Prepared for:  
Health Infrastructure NSW

Date:  
23 July 2021

# Response to Submissions Report (SSD-10434896) Multi-Storey Car Park The Children's Hospital at Westmead

Figure 1 East elevation  
Source: Billard Leece Partnership Architects

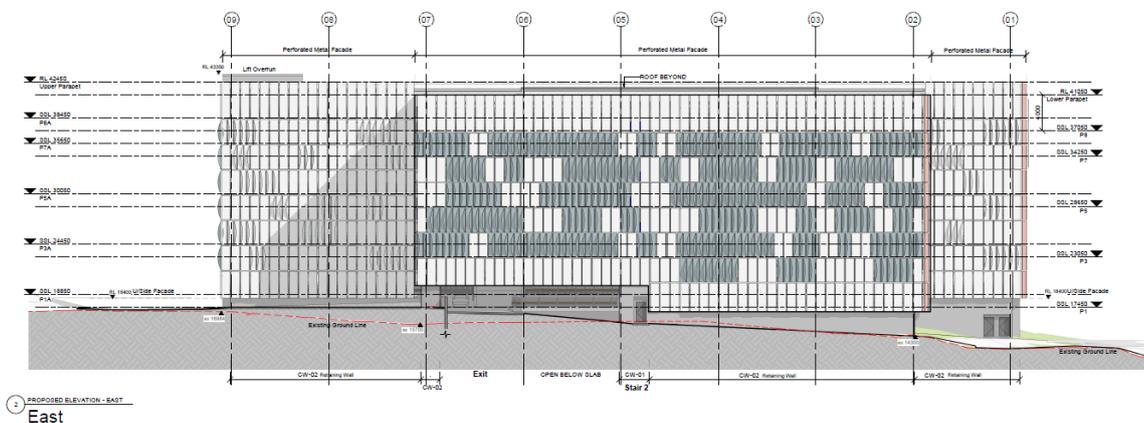
The proposed building footprint, site layout and design of the RTS proposal remain generally unchanged from that which was originally proposed. However, the RTS proposal seeks consent for a minor increase to the overall height of building as a result of cut and fill taking place between the PSB (subject of a separate planning approval) and MSCP.

The ground level has been raised by 350mm, which as a result has increased the overall maximum building height from RL 43.10 to RL 43.350 (to the top of the lift overrun). Refer to **Table 4** below.

Figure 3 Indicative Wayfinding Diagram  
Source: Billard Leece Partnership Architects

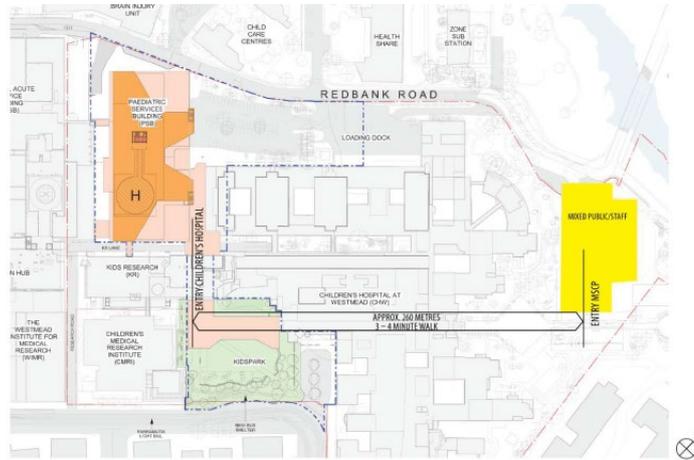
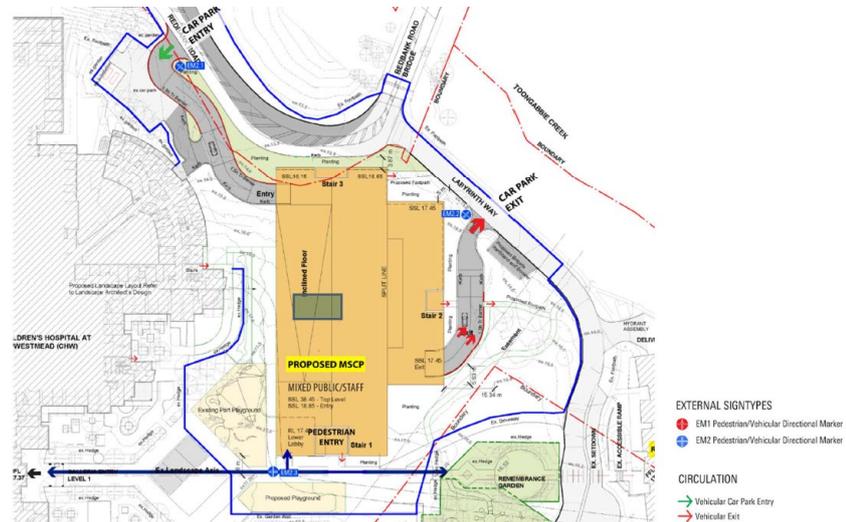
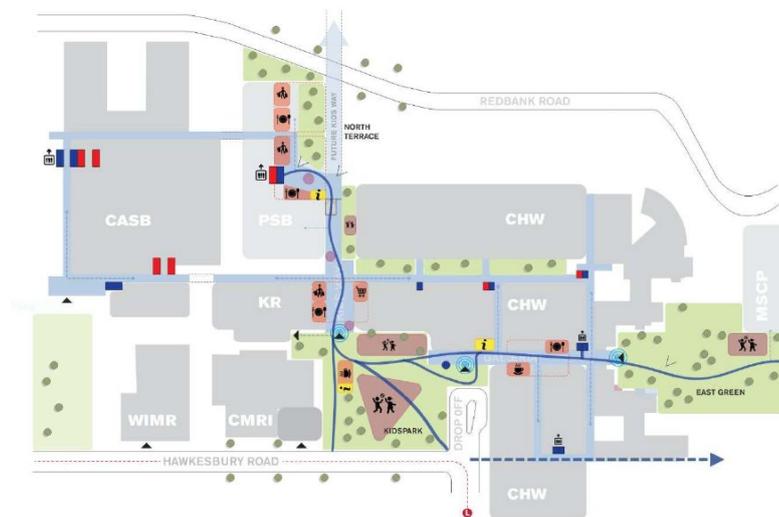
The proposed development (RTS proposal) includes revised way finding signage to reflect the wayfinding strategy, which is indicative only and subject to further development.

Refer to Section 3.4 of the revised Architectural Design Report at **Attachment B**, or extracts shown in **Figures 3 to 5**.

It is recommended that a final way finding plan be conditioned as part of the development consent. Suggested wording may read as follows:

“Way finding signage for pedestrians and cyclists must be installed prior to commencement of use of the PSB”.
